Office Action Summary	Application No. 10/604,953	Applicant(s) WRIGHT, SHAUN	
	Examiner Travis Chambers	Art Unit 2833

DETAILED ACTION

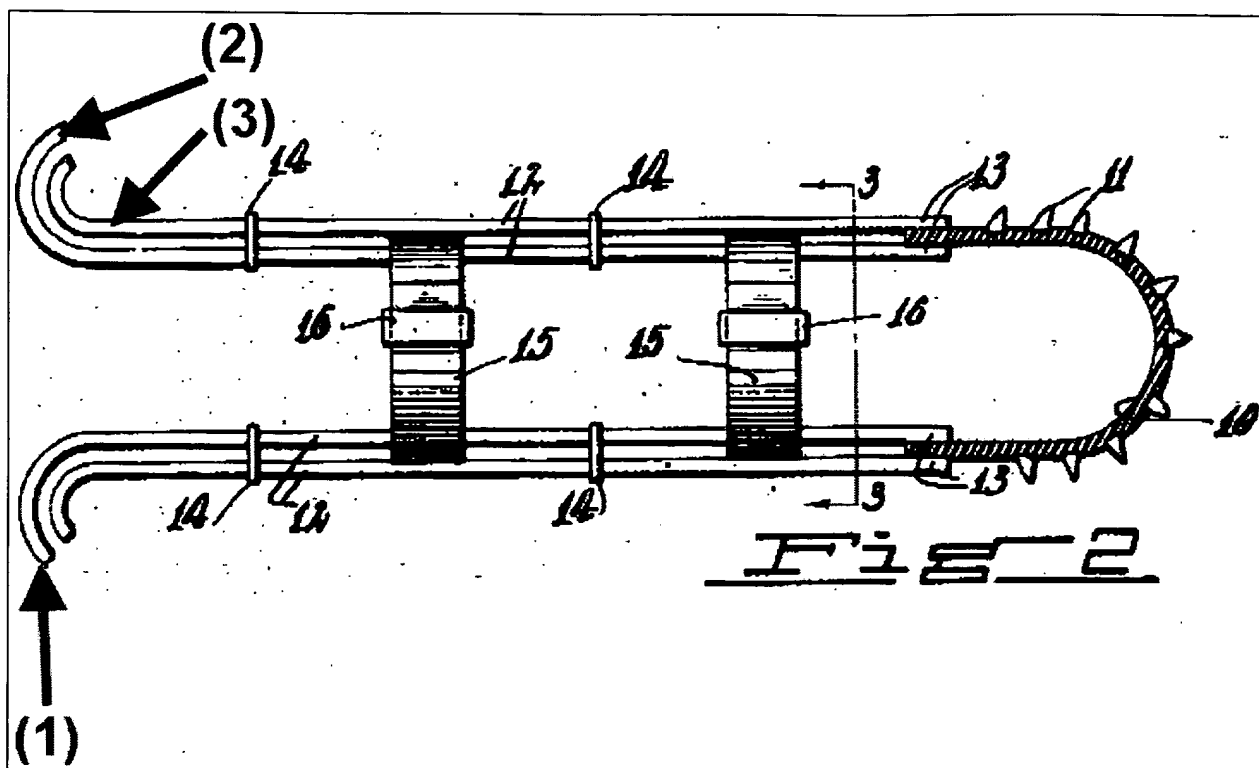
In reference to claim 1, Gonzalez teaches a globular shaped body (10 ; figure 1) made entirely from material designed to illicit specific sounds when placed in contact with one or more strings of a stringed musical instrument having a tapered inner surface (near lead line 10 ; figure 2) means to receive a musician's finger, an inner end having a hole (near lead line 13 ; figure 2) adapted to receive a musician's finger, a closed outer end (top portion 10 ; figure 2), and an outer surface for contacting strings of a stringed musical instrument encompassing said closed outer end (top portion 10), a finger ring (15 ; figure 2) and a means connecting the globular body (10) to the finger ring (15) allowing a musician's finger to bend normally.

In reference to claims 5 and 7, Gonzalez teaches where the means to connect the finger ring (15) and the globular body (10) are at least two semi-rigid strips (1,2 ;image below .

In reference to claims 9 and 11, Gonzalez teaches where the means to connect the finger ring (15) and the globular body (10) are three semi-rigid strips (1,2,3 ; image below).

In reference to claims 6 and 8, Gonzalez teaches where the means to connect the finger ring (15) and the globular body (10) are at least two semi-rigid strips (1,2 ; image below) .

In reference to claims 10 and 12, Gonzalez teaches where the means to connect the finger ring (15) and the globular body (10) are three semi-rigid strips (1,2,3; image below).

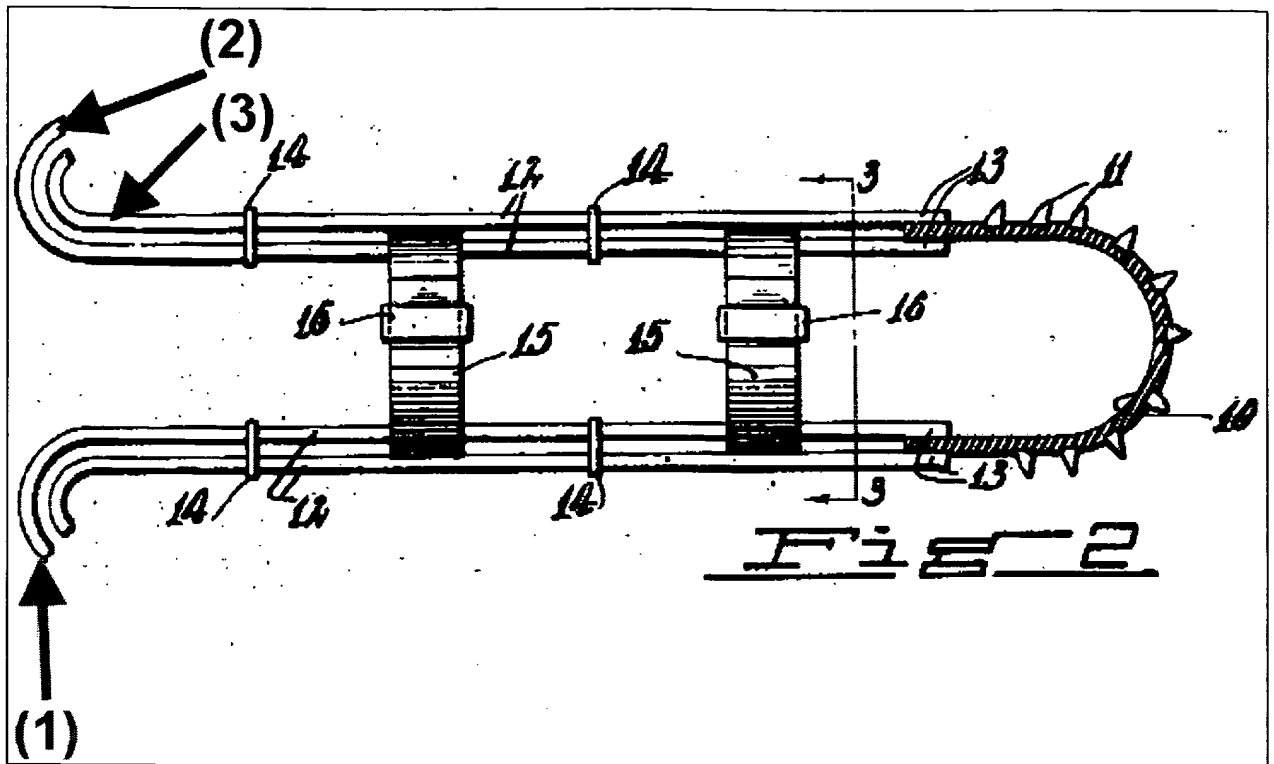
It is known in the art to change the shape of the outer surface so it can have a groove. Jones is an example that teaches of a groove (between 5 ; figure 2) present transversely across the outer surface (3 ; figure 1).
